Service Bulletin: SB-7 Rev A

SUBJECT – MIXTURE CONTROL STOP REPAIR – HA-6™ TYPE CARBURETORS.

FIGURE 1
ORIGINAL CONFIGURATION
CAST INTEGRAL STOPS

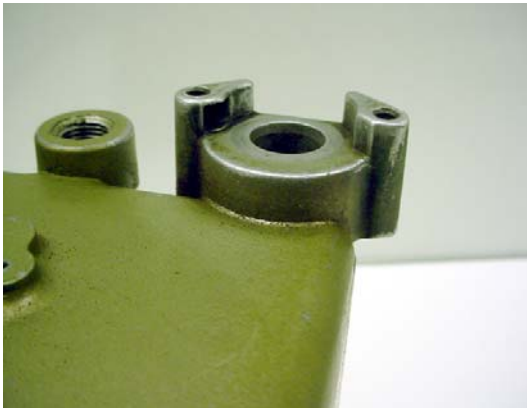
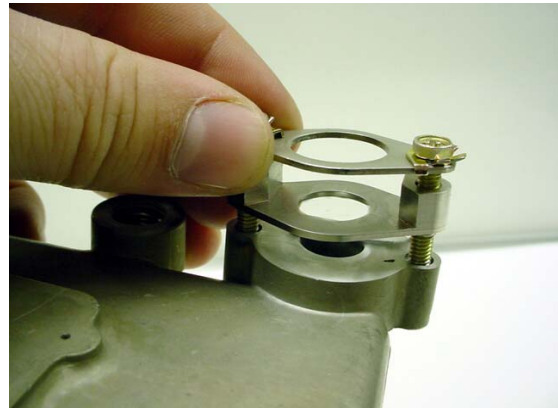
1. **Applicability:** HA-6™ model float carburetors manufactured by Volare Carburetors LLC (“Volare”), and its predecessors Precision Airmotive Corporation, Facet Aerospace Products Company, and Marvel-Schebler™ (Borg-Warner) (hereinafter “Volare”).
2. **Reason:** 1. To inform the industry that a FACTORY repair for HA-6™ mixture control stops is now available.
2. To inform service technicians that these parts are **APPROVED** for use in HA-6™ carburetors, see figures 1 & 2.
3. **Instructions:** If HA-6™ mixture control stops are found to be excessively worn, and if you wish to have this repair accomplished, contact Volare @ (336) 446-0002 ext. 005, or email customerservice@volarecarbs.com.
